APPLICATION NO.	FILING DATE	FIRST NAMED INVENTOR	ATTORNEY DOCKET NO.	CONFIRMATION NO.
10/669,576	09/24/2003	Dieter Hochrainer	1/1401	6795
28501	7590	11/01/2004	EXAMINER	
BOEHRINGER INGELHEIM CORPORATION 900 RIDGEBURY ROAD P. O. BOX 368 RIDGEFIELD, CT 06877			MITCHELL, TEENA KAY	
			ART UNIT	PAPER NUMBER
			3743

Office Action Summary

DETAILED ACTION

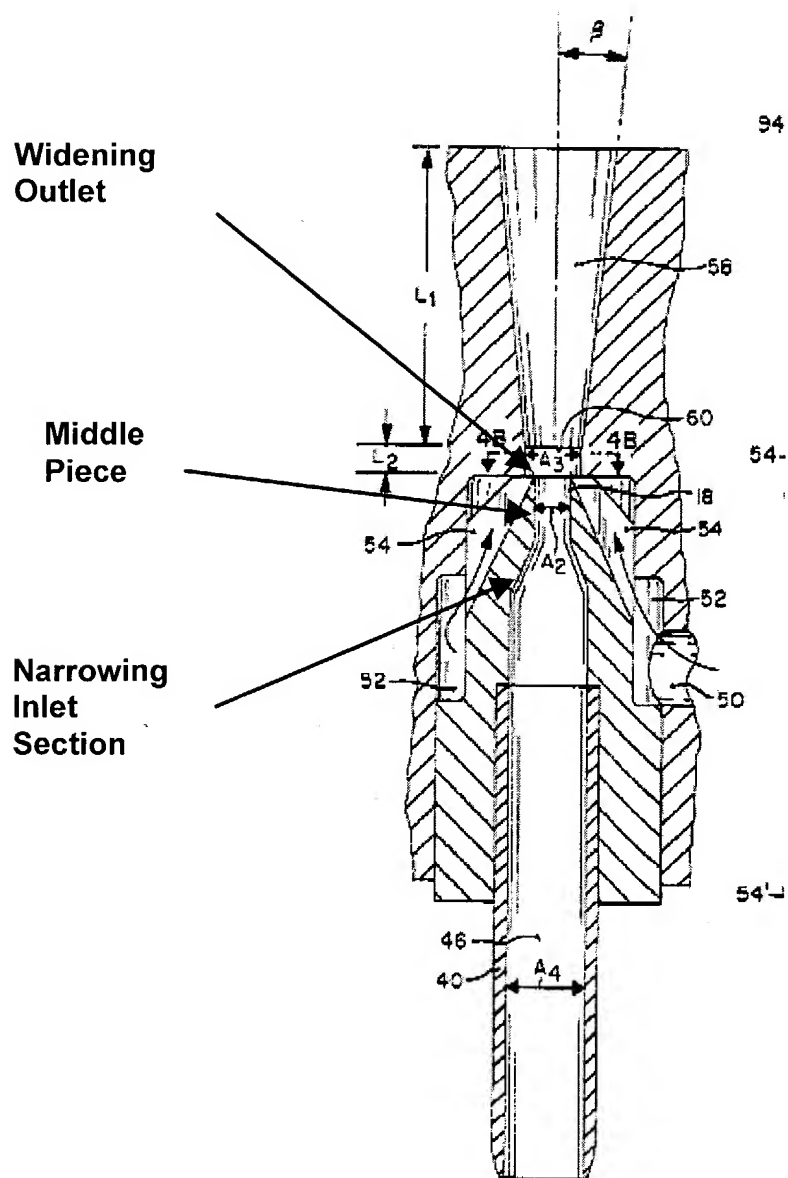
With respect to claim 2, Smith discloses that the nozzle (14) is configured as an aperture plate (Figs. 3A-4C).

With respect to claim 3, Smith discloses that the nozzle (14) exhibits a narrowing inlet section that connects with the nozzle plate (at A3).

With respect to claim 4, Smith discloses that the nozzle (14) exhibits a narrowing inlet section (see illustration of Fig. 4A below), a middle piece (see illustration of Fig. 4A below) and a widening outlet section (at 58) that connects to the middle piece.

With respect to claim 5, Smith discloses that the narrowest cross section is located in the middle piece (Fig. 4A).
